JOSEPH M. FARLEY NUCLEAR PLANT, UNIT NO. 1

AMENDMENT TO FACILITY OPERATING LICENSE

Amendment No. 54
License No. NPF-2

ATTACHMENT TO LICENSE AMENDMENT NO. 54
AMENDMENT NO. 54 FACILITY OPERATING LICENSE NO. NPF-2
DOCKET NO. 50-348

Figure 6.2-2 Facility Organization

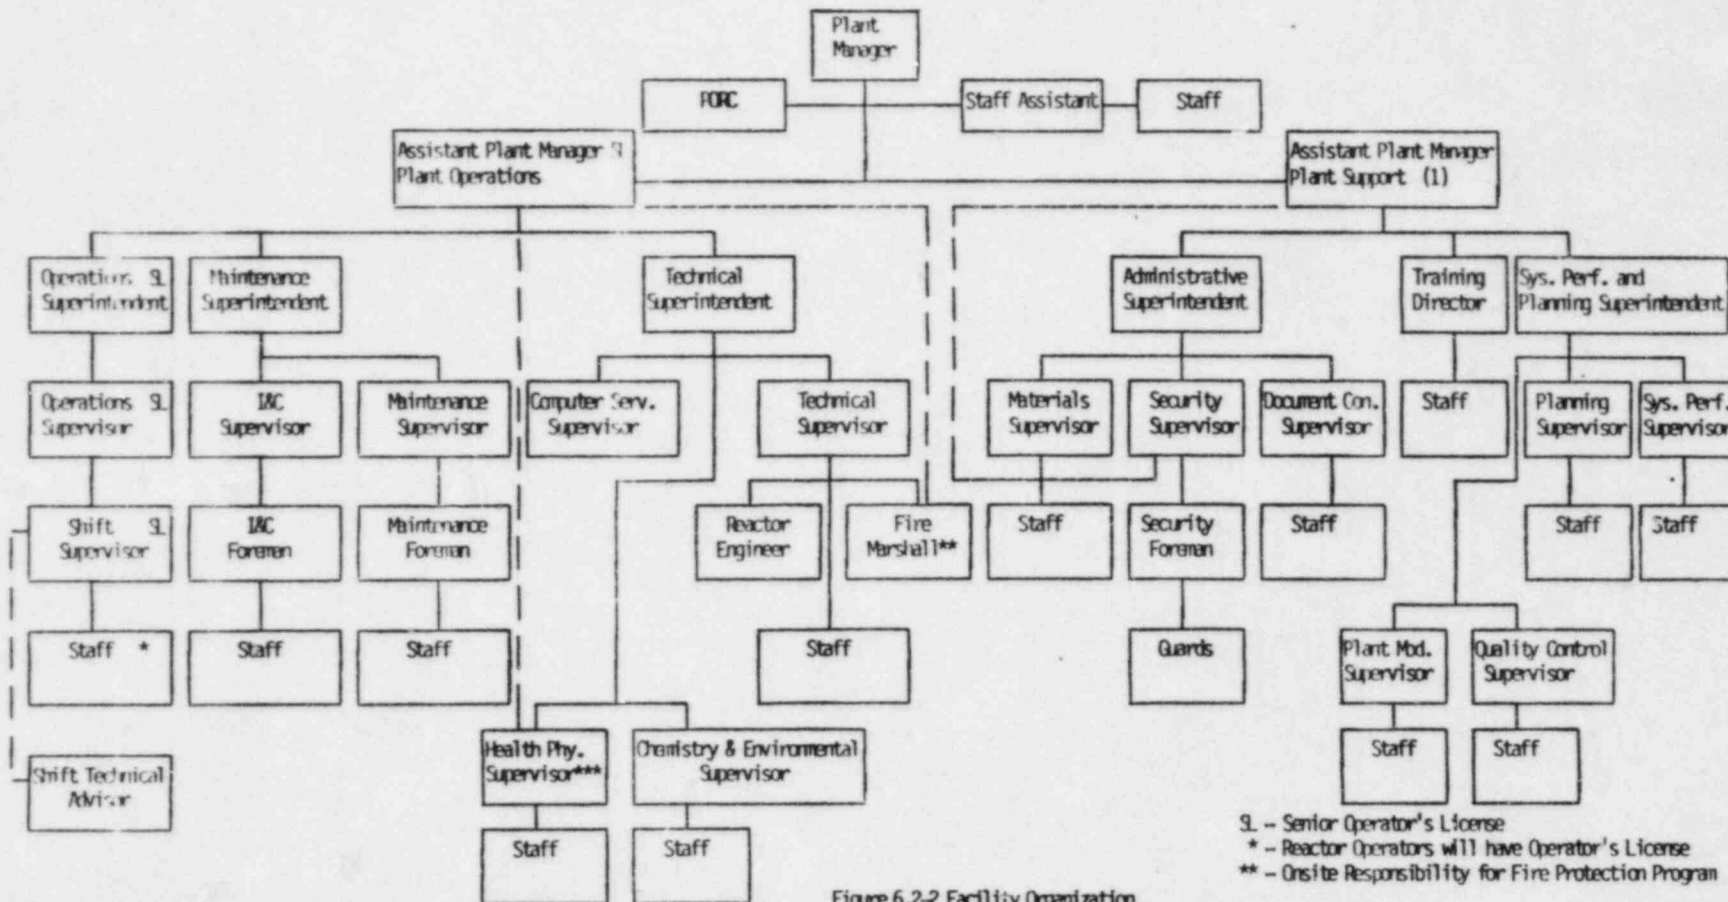
*** In routine matters, the Health Physics Supervisor reports directly to the Technical Superintendent, in matters of radiation policy determination, interpretation or implementation (Based upon the Health Physics Supervisor's judgment) the Health Physics Supervisor may report directly to the Assistant Plant Manager.

(1) The person filling this position may act as the Plant Manager, provided this person meets the requirements of ANSI N18.1-1971 Section 4.2.1, FSAR Section 13.1.3.1.1 and has completed Emergency Director Training.

Figure 6.2-2 Facility Organization

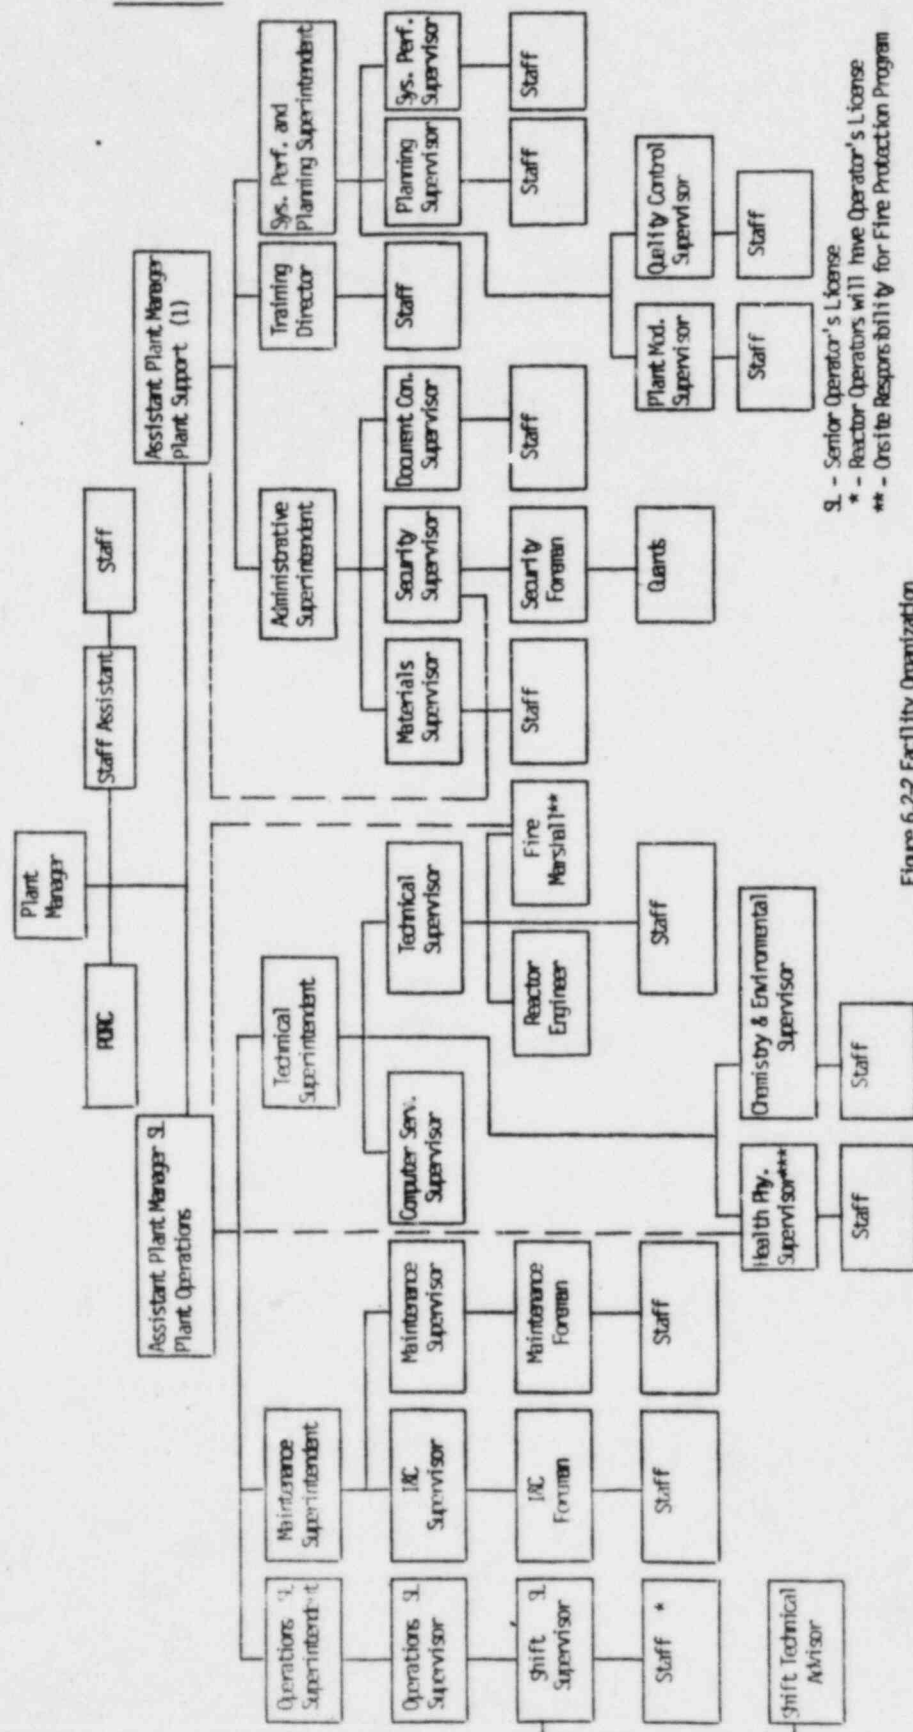
*** In routine matters, the Health Physics Supervisor reports directly to the Technical Superintendent, in matters of radiation policy determination, interpretation or implementation (Based upon the Health Physics Supervisor's judgment) the Health Physics Supervisor may report directly to the Assistant Plant Manager.

(1) The person filling this position may act as the Plant Manager, provided this person meets the requirements of ANSI N18.1-1971 Section 4.2.1, FSAR Section 13.1.3.1.1 and has completed Emergency Director Training.
